Report to Committee

RZ 07-380219

Re: Application by Toyu Group Holdings Ltd. for Rezoning at 7751,
7851 Bridge Street and 9531, 9551 Blundell Road from Single-Family Housing
District, Subdivision Area F (R1/F) to Comprehensive Development District
(CD/155)

SITE PLAN
SCALE: 1/4" = 1'-0"

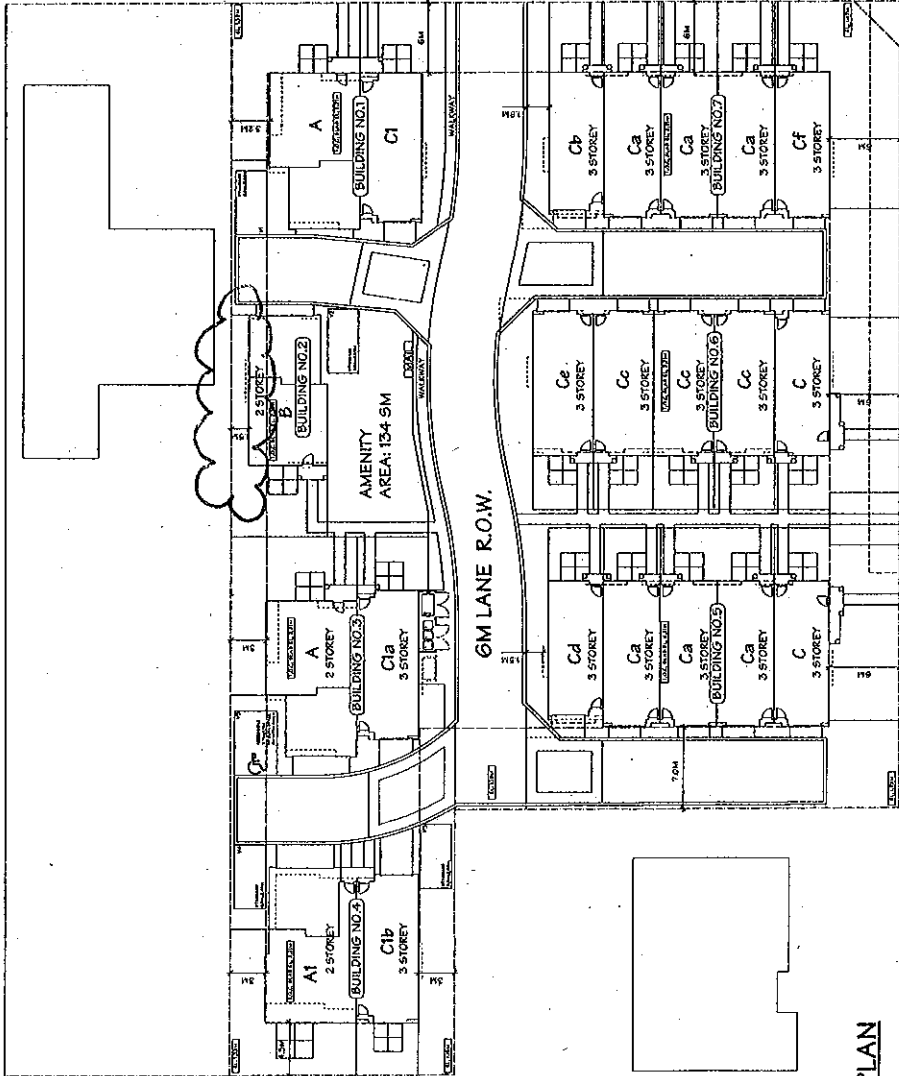
- two-storey unit A could be easily converted into an adaptable unit;
- try to locate accessible visitor parking close to the adaptable unit;
- consider increasing diversity in plant species to be used in landscaping (ex. Magnolias);

- pedestrian safety needs to be addressed in view of the public lane;
- differentiation is needed between public and private space;
- The typology seems to want to be row-housing instead of a larger mansion and back lane carriage housing. Try to reinforce the unit identities as individualized and separate;

- difficult project to conquer. The general form and arrangement of blocks is appropriate. The lane is a challenge. Concerned about children running to amenity area across lane. Lane needs traffic calming. Either step down massing south of amenity area or move it for sunlight penetration;

- entrances to buildings are too small considering the size of the buildings;
- buildings 1 and 2 on the north side can be rotated at 90 degrees so that a series of private drive aisles and building and garage entrances will be bisected by the public lane to preclude interference between the lane and unit entries;

- public and private roads can be differentiated through the paving materials used;
- landscaping along the public lane may not be advisable as it would obstruct both the motorists' view of pedestrians and access to drive-ways;

- the "tower" element that appears in two units may be more appropriate at the corner;
- brick entry from Bridge Street may not serve any purpose, does not mark private entry and can be dispensed with;

- reconsider the Blundell pedestrian entry. Nice structure, but location seems arbitrary;
- streetscape yards and frontage are good. Materials and colours to bring variety; and

- a pedestrian mews connected to Blundell instead of back yards would be more appealing.

- he does not have the same level of concern about the units fronting a public lane. Recesses and well-defined entries to the units would be necessary for pedestrian safety. There is no pedestrian access except through the public lane.
- narrowing the lane or placing bulges on both ends of the lane could be considered to slow down traffic. Or the lane could be stopped mid-block to stop through-traffic.

- turning the north units to extend the drive aisles across the lane would solve the lane interface issue, but would also likely result in a loss of units. Consider reducing the North setback to 1.2 m, reducing the Blundell setback, or shifting the lane to regain some units.
- the security of the lane could be addressed with a private look, making it inconvenient for non-residents.

That Development Permit 07-380219 move forward to the next stage taking into consideration the following comments of the Advisory Design Panel and giving staff authority to recommend whether the applicant needs to appear before the Advisory Design Panel again before moving forward:

1. consider providing the opportunity of converting unit A into an accessible unit – ***Incorporated in buildings 1 & 3;***
2. ensure that handicapped parking is near the adaptable unit – ***Incorporated. Accessible parking space is located near building 3;***

3. consider increasing the species diversity of the landscaping – ***Will incorporate through the Development Permit design;***
4. consider pedestrian circulation on the public lane – ***Incorporated. Walkway provided north of the lane;***

5. consider an alternative to the public lane for access to units along the north side – ***Resolved. Building orientation changed as suggested, resolving interface issue;***

6. consider providing some separation between the public and private grounds in the lane area – ***Resolved. Building orientation changed, resolving interface issue;***

7. consider defining the units, especially those fronting the public lane area, as having a “coach house” style rather than a “large house” style – ***Resolved. Building orientation and typology changed, so that no units are fronting the lane;***

8. consider lower massing at 2-storey volume near the amenity space – ***Incorporated;***
9. consider providing some site signage and identity for the front entry – ***Incorporated;***

10. consider breaking down the massing into lower divisions to achieve a more “row-house” pattern – ***Incorporated;***
11. consider the observation that the “tower” element that appears in 2 units to be more appropriate on a corner – ***Two and three storey duplexes along north of site prove a transition from lower single-family homes and taller townhouses;***

12. consider extending the format of the south side of the site to the north – ***Incorporated; and***
13. consider that the pedestrian entry structure from Blundell Road to drive aisle may not be valuable – ***Entry structure aligns with pedestrian walkway and entries for buildings 5 & 6.***
